# **Corkey Windfarm Repowering**

**Further Environmental Information  
Addendum No. 3 to Environmental  
Statement**

September 2020

**FIGURE 7.8**

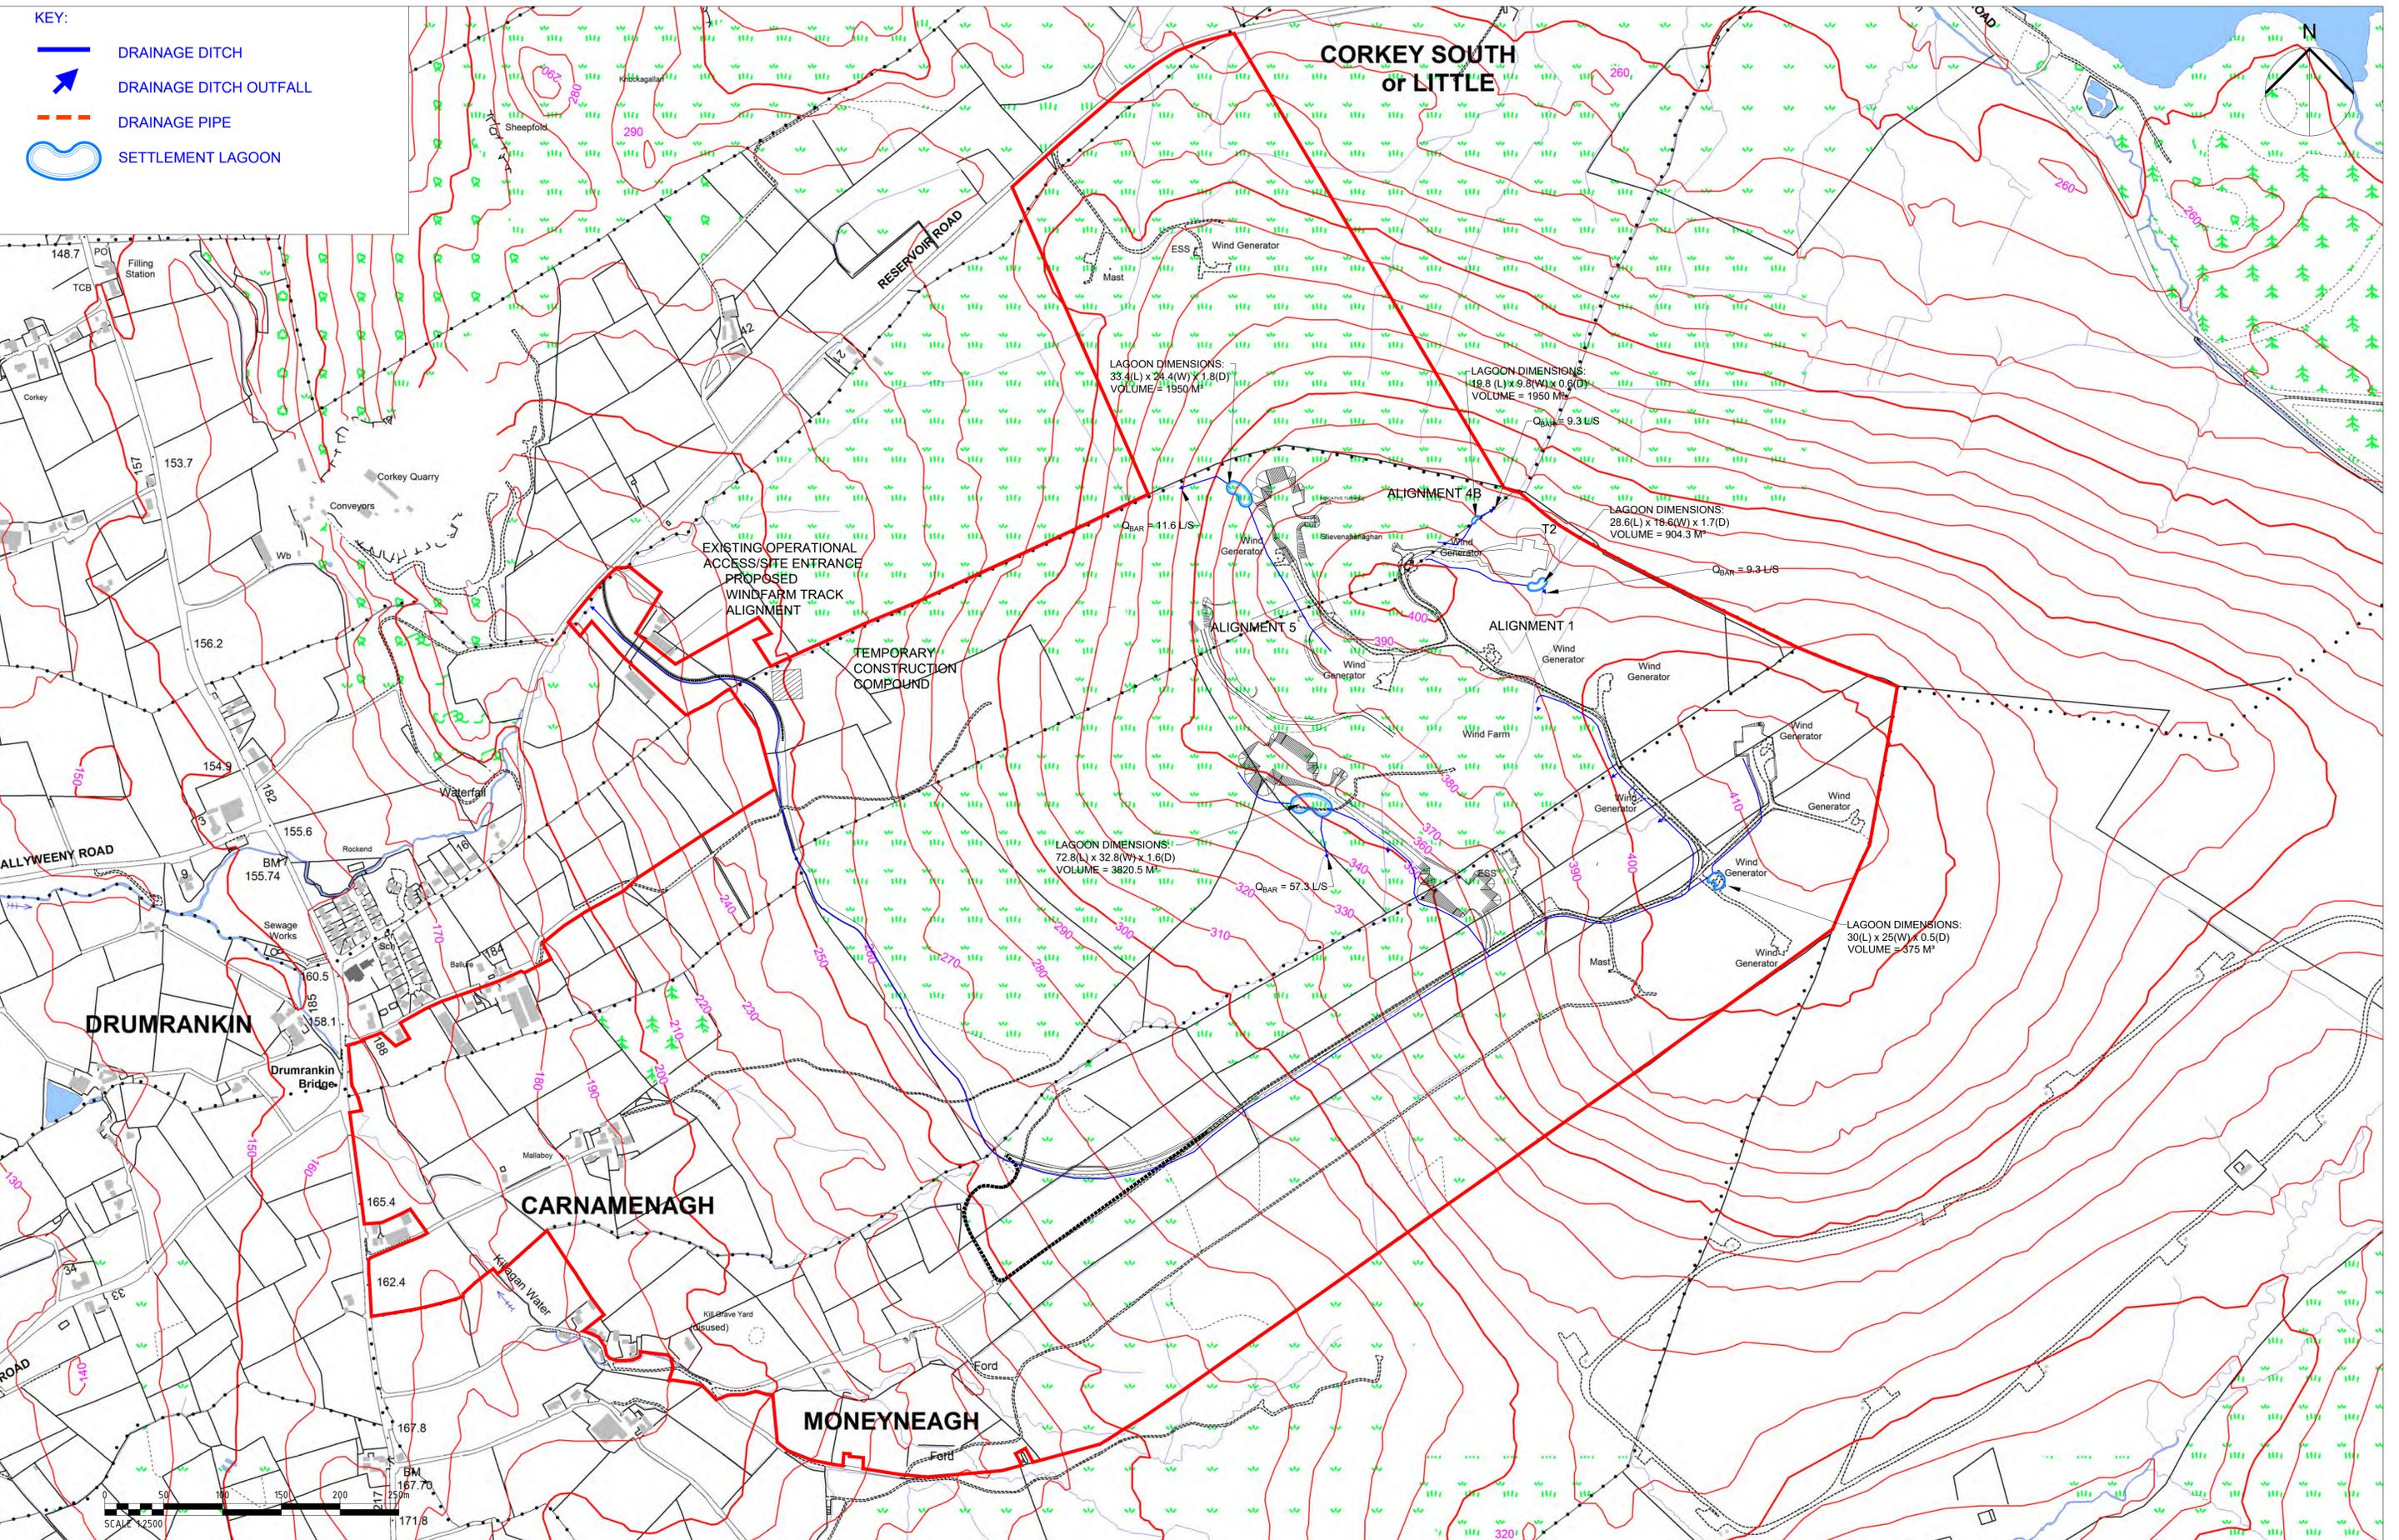
46. NED indicated a preference that the indicative location of the proposed settlement lagoon serving T1 (shown in Appendix A7.5 to Addendum 2 of the ES, submitted in May 2020) be relocated in a revised indicative drainage drawing, and the impact of this relocation be submitted and assessed as part of this Addendum.

47. NED noted that the indicative location of the settlement lagoon is on an area of active peat, which has implications for the potential loss of active peatland. Figure 7.8 of this Addendum shows a revised indicative location for the settlement lagoon at an area of existing hardstanding (made ground) associated with an existing wind turbine for the Operational Corkey Windfarm. Flow analysis has demonstrated that hardstanding for T1 (at an elevation of c. 410 mAOD) can be drained by gravity to the existing hardstanding (at an elevation of c. 405 mAOD) and therefore locating the lagoon at the existing

hardstanding is feasible. The lagoon at this location would serve only the infrastructure area associated with T1, rather than the wider catchment, and therefore would not need to be as large as shown previously. As such, the attenuation volume for surface water run-off associated with the hardstanding area for T1 has been calculated in Micro Drainage for the 1:100 year event, plus 20% climate change allowance, and the sizing of the lagoon scaled accordingly. The surface area of the revised settlement lagoon measures 750 m<sup>2</sup>. The attenuation volume required for the access track and compounds will be provided by drainage ditches / swales immediately adjacent to these elements of the Development minimising habitat loss.

48. The revised indicative location of the lagoon and the drainage infrastructure which will serve T1 is shown in Figure 7.8 of this Addendum, which supersedes and replaces the “Drainage Catchments and SuDS” figure, provided in Appendix A7.5 to Addendum 2 of the ES, submitted in May 2020<sup>1</sup>.

51. Figure 7.8 in this Addendum shows the indicative locations of construction-phase hydrological mitigation measures (drainage ditches and settlement lagoons), which would apply temporarily during the construction of the Development. Details of these measures are outlined in the Water Construction Environmental Management Plan in Technical Appendix A7.2, Volume III of the ES. The purpose of the drains and settlement lagoons is to capture surface water runoff from the development and allow suspended sediments to settle from solution, thus preventing impacts on habitats and waterbodies at the outflow points.
